**FINAL DRAINAGE REPORT  
FOR  
TAMLIN ROAD RV STORAGE-EXPANSION  
EL PASO COUNTY, COLORADO**

Job No. 25305.00

PCD File No.: PPR2437

# DETENTION BASIN STAGE-STORAGE TABLE BUILDER

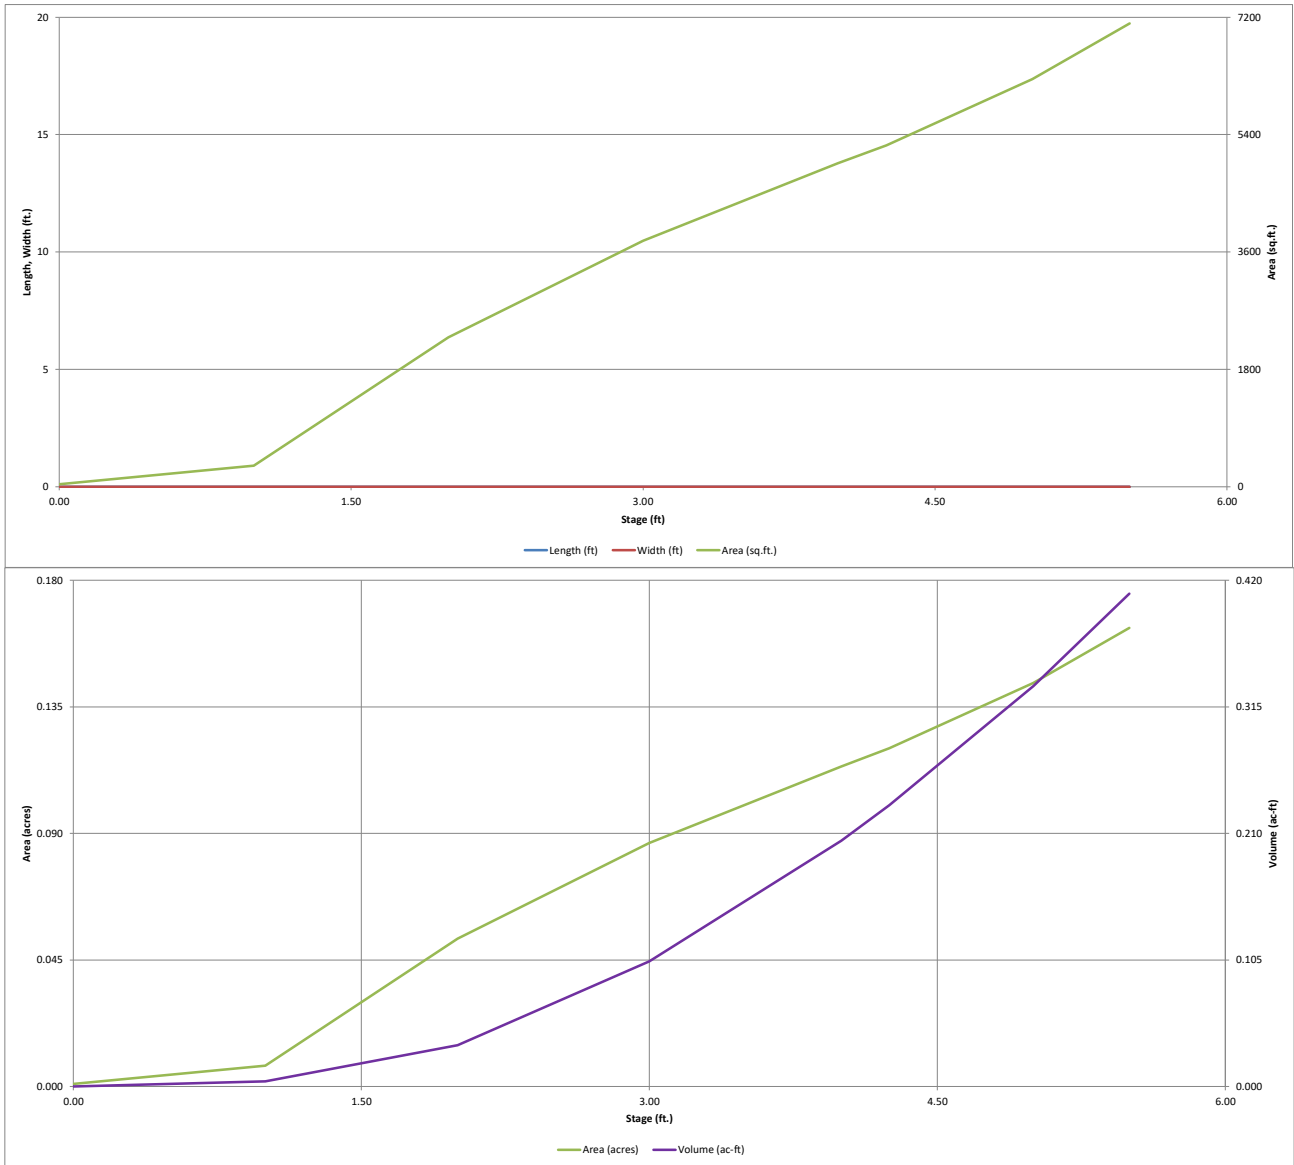
✓ = calcs match details in plans  
 X = calcs do not match details in plans
